Subject: Bishop Tube Public Comment

**Comments on the Bishop Tube Site 8/17/2021
Analysis of Alternatives and Proposed Response**

The following are comments on the 8/17/2021 *Analysis of Alternatives and Proposed Response* (the “AOA”) for the Bishop Tube Property, East Whiteland Township, Chester County (the “Site”¹) from the Hazardous Sites Cleanup Program of the Commonwealth of Pennsylvania, Department of Environmental Protection (the “Department”).

I write to provide comments on the *Remedial Investigation Report (RIR)* and *Feasibility Study Report (FSR)* regarding the Former Bishop Tube Property, East Whiteland Township, Chester County, Pennsylvania, authored by Roux Associates, Inc. (2019a and 2019b). As you will read, I find that the analyses presented in the RIR are deficient in several respects; and I offer suggestions for improving upon these analyses. Because the FSR is based on the RIR, it too is unreliable.

Figure 9: Snapshot from FS Addendum Figure 1 showing the location of the two areas to receive active soils and groundwater treatment.

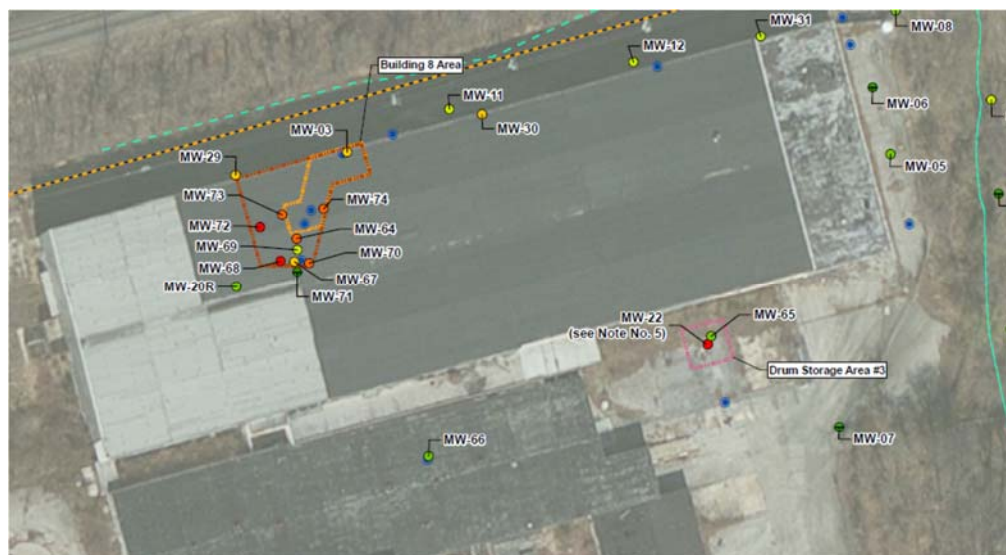
The soils remediation would involve using ISCR to treat in place the unsaturated soil at two locations (Figure 9), AOC 1 (Building 8 vapor degreaser area) and AOC 9 (Drum storage area near Building 5). The soil would also be mixed in place to enhance the placement of the ISCR amendments. Groundwater alternative 3 would be reduced to utilize ISCR at just two much smaller onsite locations (Figure 9) rather than the areas shown in Figures 3, 4 and 5. There would be no treatment of offsite areas north of the site.

This new alternative 8 leaves substantial TCE in the groundwater and is even less effective than other FS injection alternatives. This alternative leaves many areas, especially the high TCE concentration in the preferential flow zone offsite north of the northeast corner of the site.
